CORRIGENDUM - III

Tender No.: UCSL/CC/SER/T/CIVIL/121/2025

SUBJECT: RENEWAL OF RAINWATER GUTTER AT UCSL. HANGARAKATTE YARD.

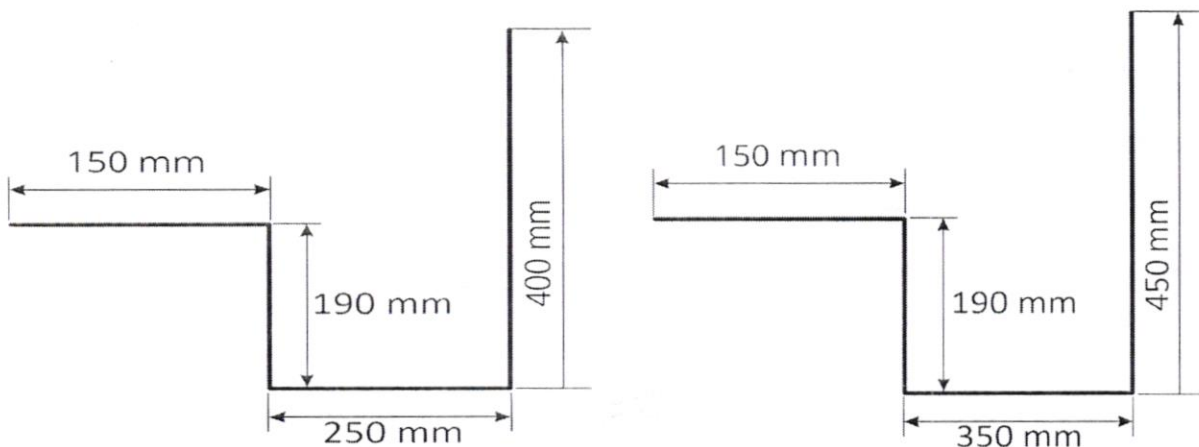
1.1. Renewal of the existing rainwater gutter system between Bay 2 & 3, CS Bay side and Bay 1 at UCSL, Hangarkatte Yard. The scope includes dismantling the existing gutter, fabricating and installing a new Galvalume gutter, and reconnecting the drainage system. Approximate length and dimension of gutter is as mentioned below.

Sl. No	Description	Qty	UOM
1	Between Bay 2&3 gutter renewal including sheet removal and refit and drain	100	Meter
2	CS Bay side 2&3 gutter renewal including sheet removal and refit and drain	140	Meter
3	Bay 4 flashing sheet renewal	28	Meter
4	Rate Supply of new sheet	150	Meter Square
5	Providing slope for existing 8-inch pipe between bay 2 & 3	1	Lump Sum
